Substantive Site Plan Approval Application

Supplemental Report to the Design Review Committee

January 21, 2014

Fig.1 The Conserved Bank of Commerce Building with hotel plaza beyond.

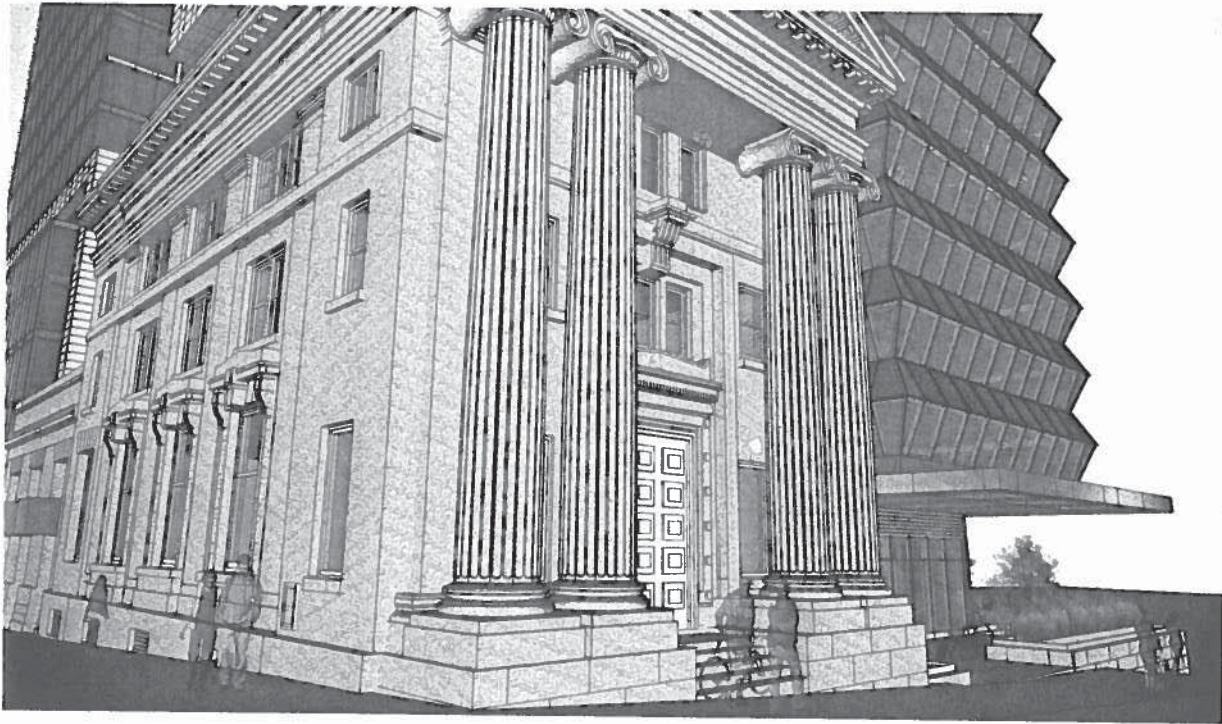
It was expressed by certain Committee members that the design of the hotel might be too expressive given its proximity to the Bank of Commerce building. It is the intention of the proposed design to create a dialogue between the two built forms as a way of expressing their unique architectural qualities. The development, in accordance with the Design Manual (ref: 4.4.1) provides setbacks against each side of the Bank of Commerce building. Along George Street, the setback is provided via the atrium located between the Bank of Commerce building and the ribbon wall. The ribbon wall provides a quiet backdrop against the Bank of Commerce building and provides additional separation to the hotel, whose articulated facade is additionally setback from the ribbon wall. This layered setback creates sufficient space between the forms so as to allow a respectful and ideological dialogue to occur. Each form has its own unique articulation that is specific to its time, place and purpose.
